From: wastewaterdeveloperservices@uuplc.co.uk
Sent: 08 September 2022 13:41
To: Tara Urding
Cc: Dameon Kilgour; Billy Hayton; Tony Spencer
Subject: RE: PDE 4200034146 Junction of Deansgate South M3 4LB (20047) - New Ref. 0237423
Attachments: ATT00001.txt

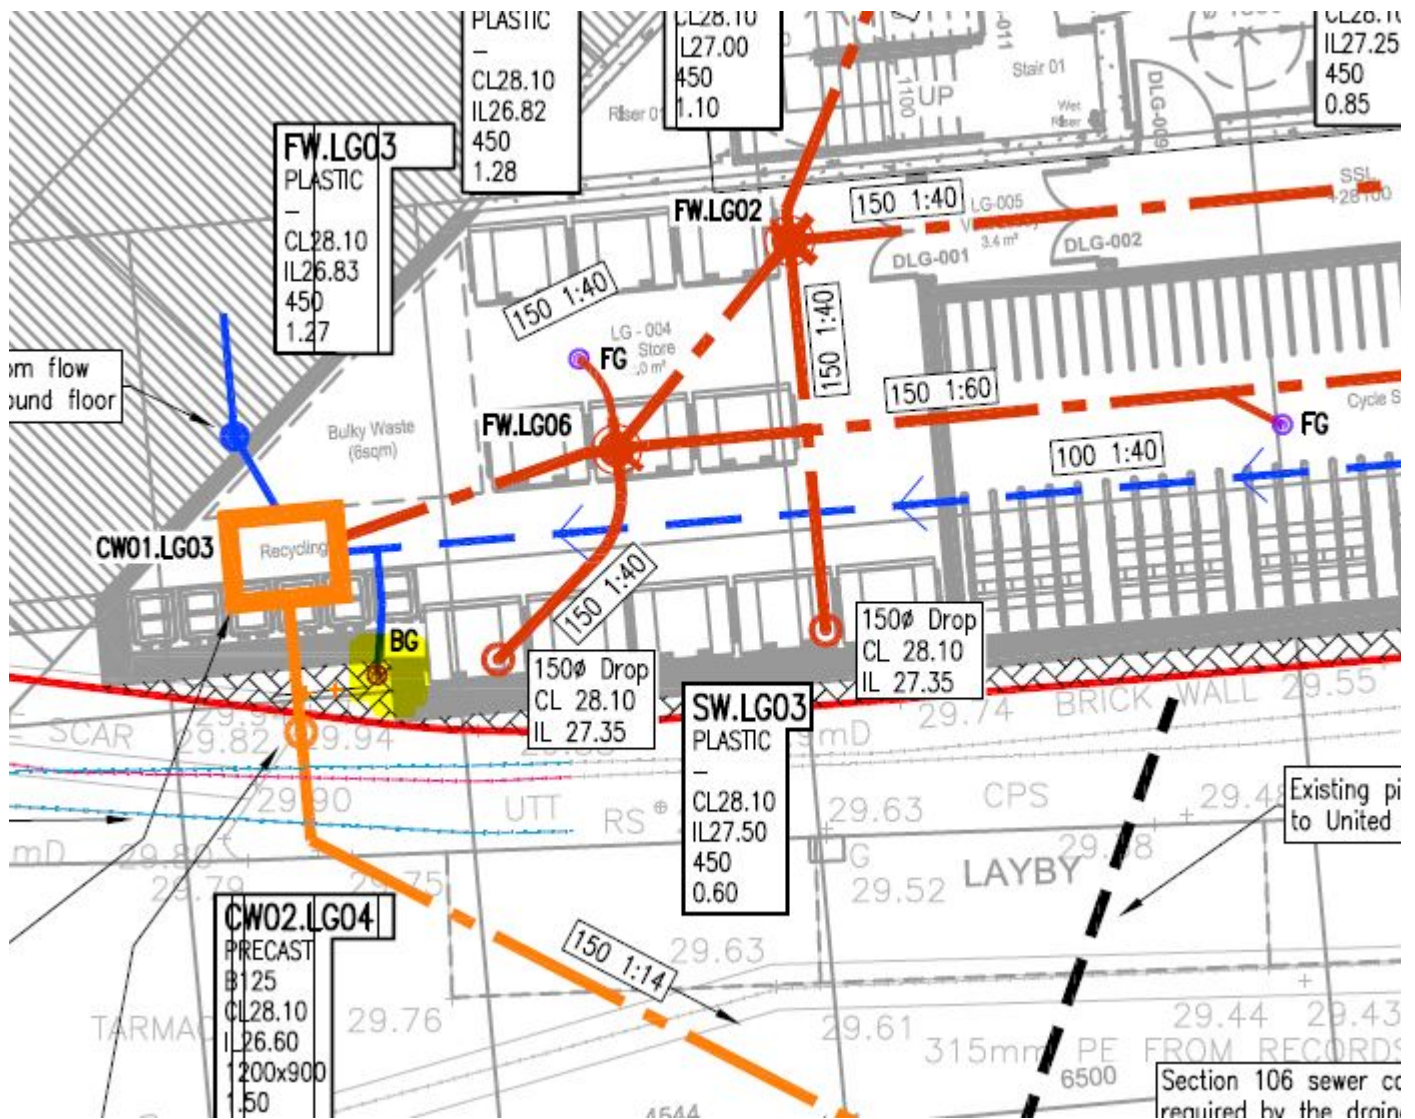
The bottle gullies that you've highlighted drain an area of 13m² along the southern margin of the development. The rate of discharge from this area peaks at approximately 0.3 l/s during a short intense rainfall event. This is equivalent to a rainfall rate of 85mm/hr.

We could propose designing the system so that the main hydrobrake restricts discharge to 4.5 l/s, and allow the bottle gullies to discharge after the hydrobrake at 0.3 l/s and for the permeable paving to discharge at a controlled rate of 0.2 l/s, as indicated previously.

Alternatively, we could move the permeable paving control to a location downstream from the bottle gullies so that the discharge backs up into the permeable paving. Controls would be adjusted to ensure 5.0 l/s is not exceeded.

The amendment drainage drawing (20047-121, Rev: B) appears not acceptable. This is because the drawing shows there is a surface water sewers (highlighted in yellow) drain to network after the hydro brake manhole. The developer needs to redesign the drainage network to achieve a total of 5 l/s discharged from the site.

Regarding your first email, we preferred the second solution, which is "move the permeable paving control to a location downstream from the bottle gullies so that the discharge backs up into the permeable paving. Controls would be adjusted to ensure 5.0 l/s is not exceeded."

Please amend the drainage design to be consistent with what is stated above.
